## STAFF REPORT COMMUNITY DEVELOPMENT DEPARTMENT

HEARING DATE: 2/9/2021  
TO: Mayor & City Council  
FROM: Alan Tiefenbach, Associate Planner  
208-489-0573  
SUBJECT: FP-2020-0017  
Lupine Cove Final Plat  
LOCATION: 4000 N. McDermott Rd., in the NW ¼ of  
Section 33, Township 4N., Range 1W.

## B. Final Plat (date: 2/24/2021)

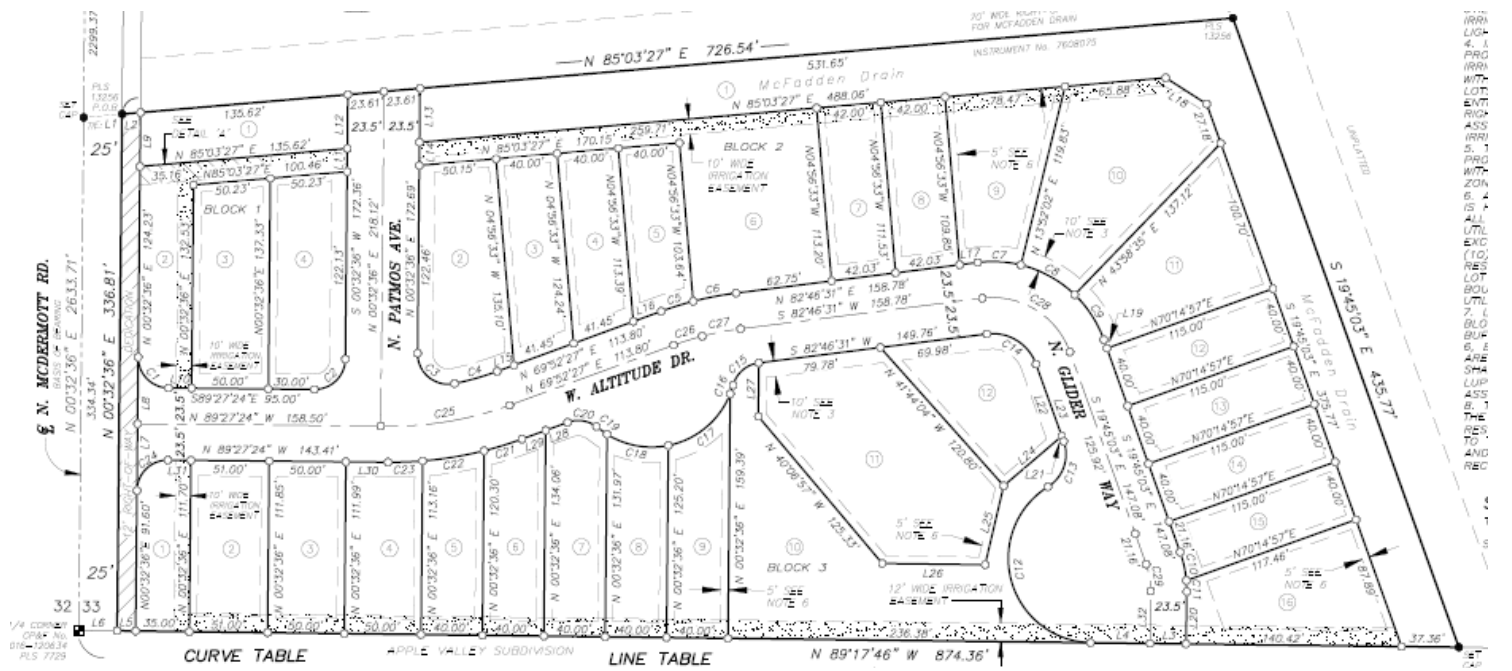
- a. Add a note to the final plat that prohibits direct lot access to N. McDermott Road.
  - b. Correct note #3 reference from "Boise" to "Meridian"
  - c. Revise note #7 to remove the text "are designated landscape buffers."

- d. Add the following note: The bottom of structural footing shall be set a minimum of 12-inches above the highest established normal ground water elevation.

- e. Add the following note: Maintenance of any irrigation and/or drainage pipes or ditches crossing a lot is the responsibility of the lot owner unless such responsibility is assumed by an irrigation/drainage entity or lot owner's association.
